**Proposed Amendments to the Heavy-  
Duty Engine and Vehicle Omnibus  
Regulation and Associated  
Amendments; 30-Day Notice** )  
)  
)  
)

**COMMENTS OF THE  
TRUCK AND ENGINE MANUFACTURERS ASSOCIATION**

June 4, 2021

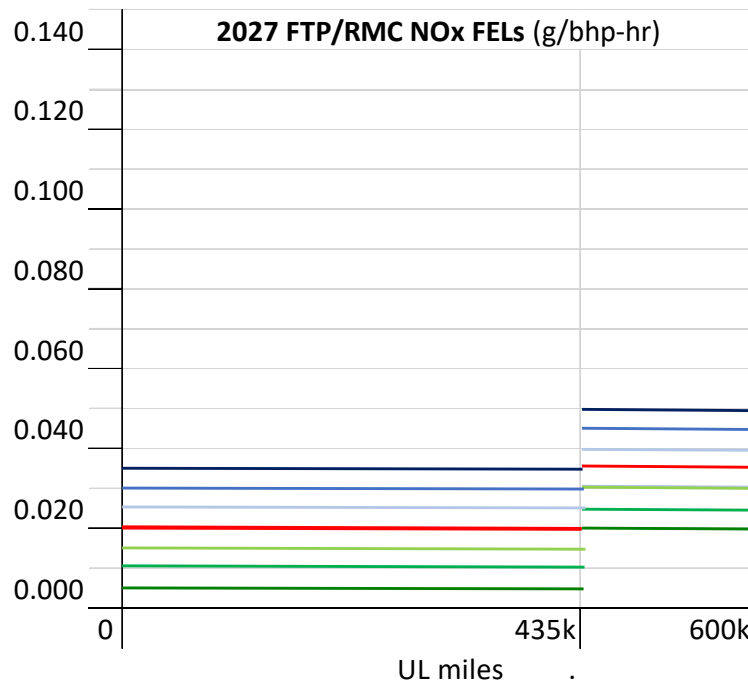
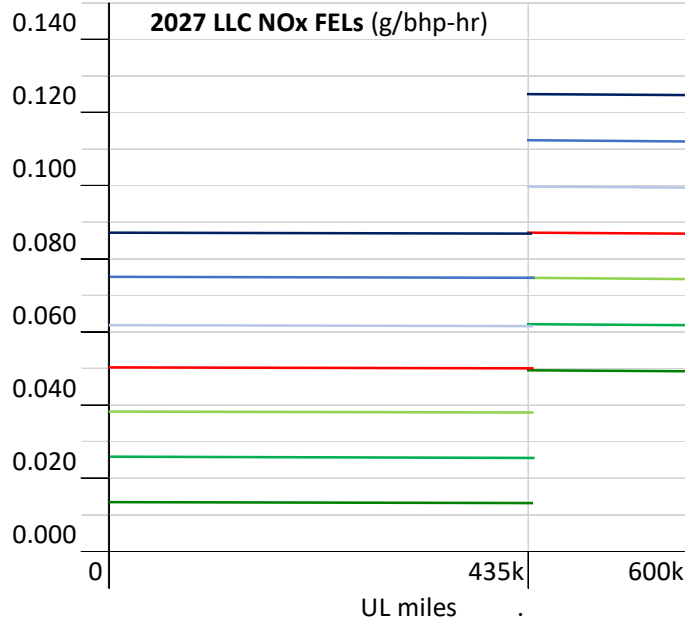
**§86.xxx-15.B.3.(i)(1):** The HHDDE maximum NOx FTP FEL levels (“FEL caps”) of 0.100 and 0.050 g/bhp-hr are expressed as figures ostensibly comparative to the 2024 through 2026 MY FTP NOx standard of 0.050 g/bhp-hr, and the 2027 and later MY FTP NOx standard of 0.020 g/bhp-hr, respectively. EMA believes that CARB intended that that these FEL caps are the maximum allowable levels of the Intermediate Useful Life (IUL) standards, rather than the Full Useful Life (FUL) standards shown in the table of 86.007-11.B.5.3.3., and discussed in the provisions for determining Intermediate Useful Life FELs in §86.xxx-15.B.3.(i)(4). For consistency of approach, and recognizing that the NOx standards as described in the table 86.007-11.B.5.3.3. are actually FUL standards, and also that the FEL calculation methods of §86.xxx-15.B.3.(i)(4) are based on the FUL NOx standards, EMA recommends that CARB establish the NOx FEL caps for 2027 and later MYs as FUL FEL caps. By CARB’s proposed requirements of §86.xxx-15.B.3.(i)(4), the FUL NOx FEL caps would be as follows:

If CARB were to accept EMA’s recommendation regarding the NOx FEL calculation methods of §86.xxx-15.B.3.(i)(4) below, then the 2027 FUL NOx FEL cap would be as follows:

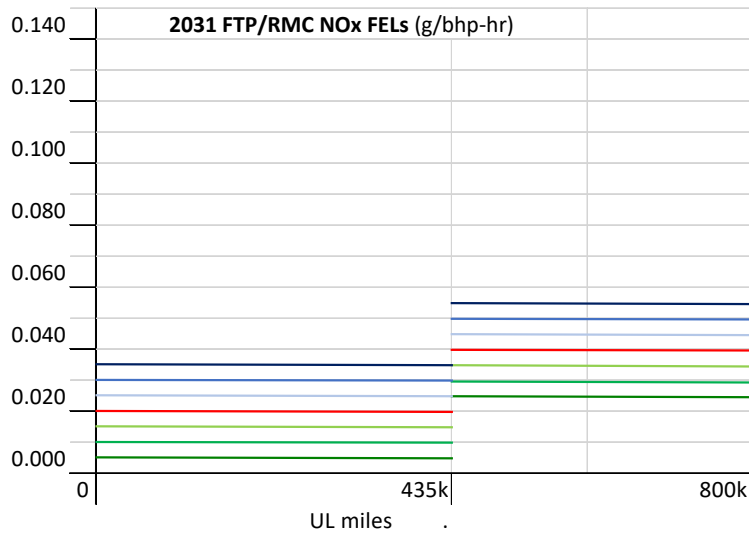
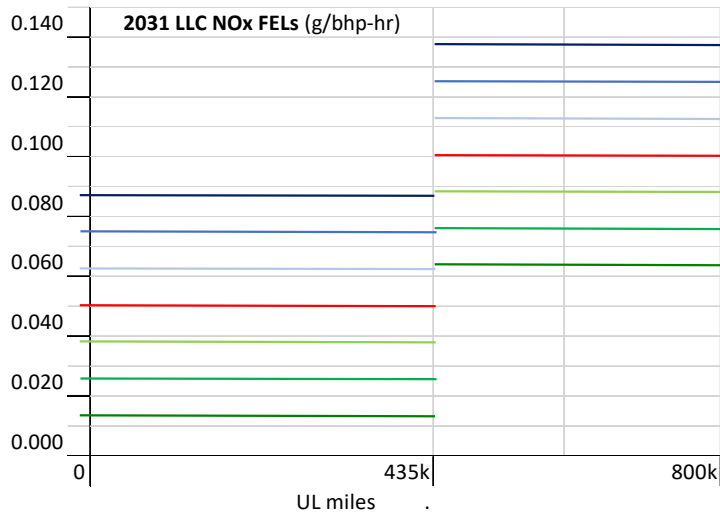
§86.xxx-15.B.3.(i)(4) proposes a method for determining MY 2027 and later Intermediate Useful Life (IUL) NOx FELs based on the Full Useful Life (FUL) NOx FELs to which the family is being certified. (The RMC and LLC Full Useful Life NOx FELs are determined based on the Full Useful Life FTP NOx standard as described in §86.xxx-15.B.3.(i)(2) and (3)(A).) The calculation process proposed produces an outcome where the difference (in g/bhp-hr) between the Intermediate Useful Life NOx FEL and the Intermediate Useful Life NOx standard is set to be equal to the difference between the Full Useful Life NOx FEL to which the family is being certified and the Full Useful Life NOx standard.

Below is a table of FTP and LLC NOx FELs for a range of potential Full Useful Life NOx FELs for MY 2027-2030 standards (the figures in red are the actual standards), calculated according to the proposed method:

The same FELs are represented graphically below, first for the FTP NOx FELs (and RMC FELs, which, by the regulation, are equivalent to the FTP NOx FELs), then for the LLC NOx FELs (the red line is the actual standard).

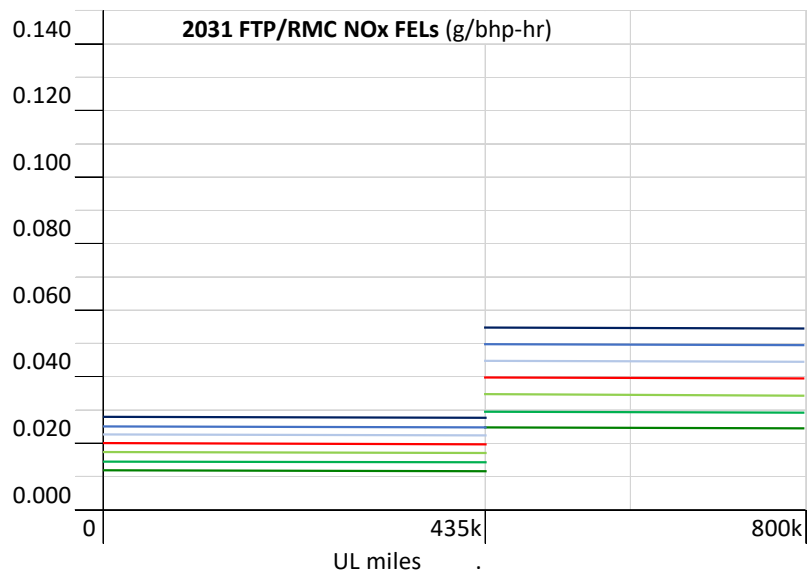
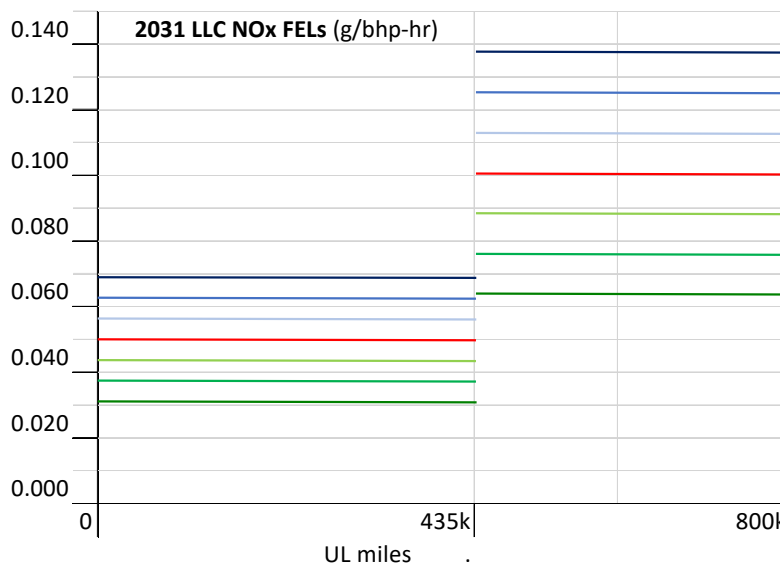
One outcome of this proposed methodology is that, for example with respect to the 2027-2030 MYs, a FUL FTP NO<sub>x</sub> FEL of 0.020 g/bhp-hr would be 4 times the IUL FTP NO<sub>x</sub> FEL of 0.005 g/bhp-hr, whereas the FUL FTP NO<sub>x</sub> FEL of 0.050 g/bhp-hr would be only 1.4 times the IUL FTP NO<sub>x</sub> FEL of 0.035 g/bhp-hr. The RMC FELs would be equally impacted in this way, and similar anomalies can be found from the results of the required NO<sub>x</sub> LLC FEL calculations, and for all NO<sub>x</sub> FELs for the 2031 and later model year standards.

EMA recommends a different approach to setting the IUL NO<sub>x</sub> FELs based on the FUL FTP NO<sub>x</sub> FEL, where the ratio of the FUL NO<sub>x</sub> FEL to the IUL NO<sub>x</sub> FEL is established to be equivalent to the ratio of the FUL NO<sub>x</sub> standard to the IUL NO<sub>x</sub> standard. This would mean, effectively, that if an FUL NO<sub>x</sub> FEL were 50% below the FUL standard, the IUL NO<sub>x</sub> FEL would also be 50% below the IUL standard. The result of the EMA-recommended method is presented graphically below for the same range of potential FUL FTP NO<sub>x</sub> FELs:

EMA believes that establishing IUL NOx FELs based on the ratio of the FUL to IUL standards is a more rational approach than the one proposed in the 30-Day Notice. EMA recommends CARB adopt this preferred approach for determining FELs in the Final Rule.

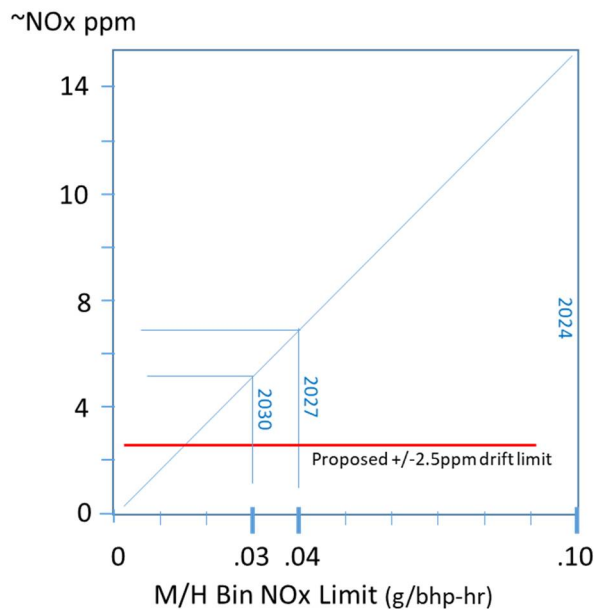
We appreciate that CARB has recognized the significant impact that PEMS NO<sub>x</sub> measurement drift can have on the measurement accuracy, which is critically important in the context of the very low NO<sub>x</sub> levels that PEMS will need to measure and record, and the very stringent standards established under the Omnibus Low NO<sub>x</sub> Regulations. This is especially true for the Medium/High bin, where the standard requires a maximum allowable average NO<sub>x</sub> concentration of 7 to 8 ppm (MY 2030 and later, when the conformity factor is reduced to 1.5). In light of that ultra-low standard, CARB has proposed to reduce the maximum allowable level of PEMS drift for NO, NO<sub>2</sub>, and NO<sub>x</sub>, from earlier proposed drift levels of +/-5 ppm, to +/-2.5

ppm at any zero-check (relative to the pre-test zero). Emissions recorded when the zero-check has exceeds +/-2.5ppm would be invalid. The remaining valid data would be corrected by Equation 1065.672-1.

As can be seen from the RMC emissions test results generated with the SwRI Stage 3 engine (set forth in the table below), NOx levels of 1 to 3 ppm will necessarily dominate most Bin 3 operation if compliance is to be achieved. Consequently, it will be critical to accurately measure those 1 to 3 ppm NOx levels, so that the day’s average emissions in the bin (including inevitable transient NOx breakthroughs, for example, during a “return to service” event following a period of extended idling or coasting), can reliably demonstrate a passing level. Very small errors of +1 to +2 ppm (after correction) when measuring 3 ppm or lower NOx levels, will almost certainly lead to determinations of Bin 3 noncompliance for engines which are actually meeting the standard. This issue goes to the core of the likely infeasibility of the Bin 3 requirements.

Proposed PEMS NOx zero-drift limit compared to in-use Medium/High Bin NOx standards.

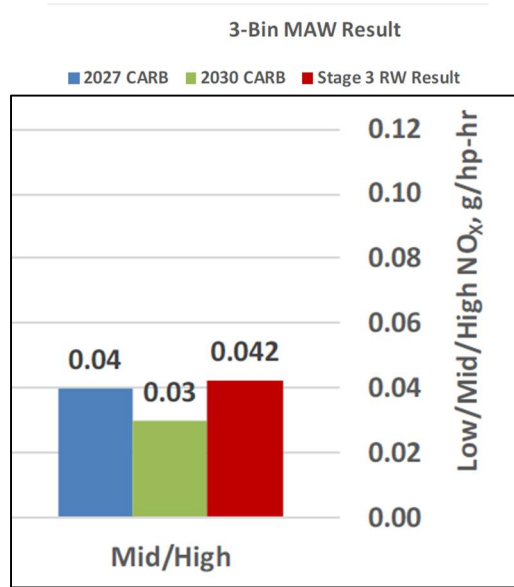
The scale of the maximum allowable PEMS NOx zero-drift during a test-day relative to the very stringent Medium/High Bin in-use NOx limits is shown in the following graph, and clearly reflects the extreme sensitivity of Bin 3 NOx compliance to zero-drift.

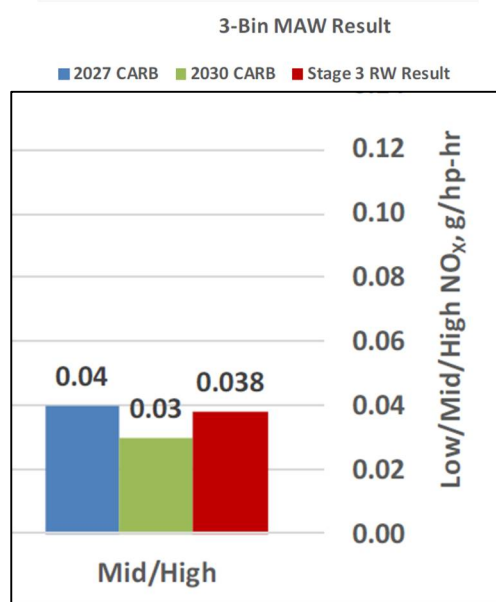
The 3B-MAW Medium/High Bin NOx standards are so challenging that the SwRI Stage 3 engine and aftertreatment system developed and calibrated for the specific purpose of demonstrating the feasibility of the Omnibus Low NOx standards is actually incapable of meeting the 2031 and later in-use requirements for two of five routine road-cycle applications when assessed after 435,000 miles of aftertreatment aging (even before considering CARB's extended FUL and durability demonstration requirements). The Medium/High Bin results from SwRI's testing for the Drayage Cycle developed by West Virginia University are shown here:
